SERVICE BULLETIN

NUMBER: M20-224

SUBJECT:

FUEL FLOW TRANSDUCER, AEROSONIC PART NO. 32622-6

FIGURE I

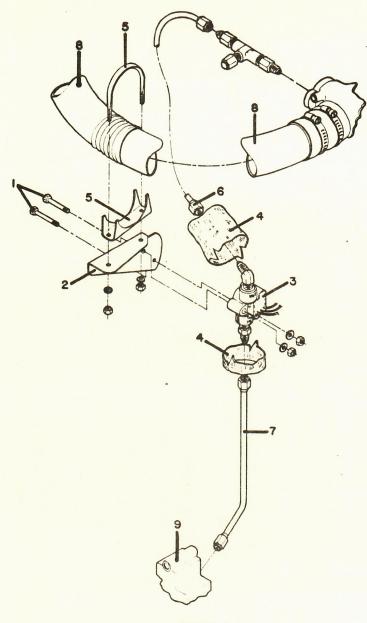
It has been determined that certain transducers manufactured by Aerosonic were improperly assembled and on some installations may leak or come apart during engine operation. This Bulletin requires inspection and replacement of suspect transducers on above aircraft serial numbers.

General: Unless the transducer has been replaced on the aircraft serial nos. listed above since new, the transducers must be replaced.

Other aircraft listed above without specific S/N's will require inspection per the following:

- 4) Loosen the nuts on the C10Y-34-6S clamp assy and rotate bracket and clamp so the back side of the transducer is exposed. Inspect for the name "FLOSCAN" embossed on the backing plate of the transducer housing. If the name "FLOSCAN" is found on unit it does not need replacing.

- 5) If no name is found on the backing plate, the transducer must be removed and replaced with a "FLOSCAN" unit.
 - a. Disconnect the fuel lines from the transducer ports.

- b. Remove sleeving from knife blade type connections and disconnect.
- 6) Install and secure the new transducer and leak check all fuel fittings prior to covering with the firesleeve. Install 45° elbow and union to transducer to a minimum torque of 40 inch/lbs., rotate to index to position. If leak persists, tighten one full turn, do not overrun or back off. Torque fuel line flare nut fittings to 50-90 inch/lbs.
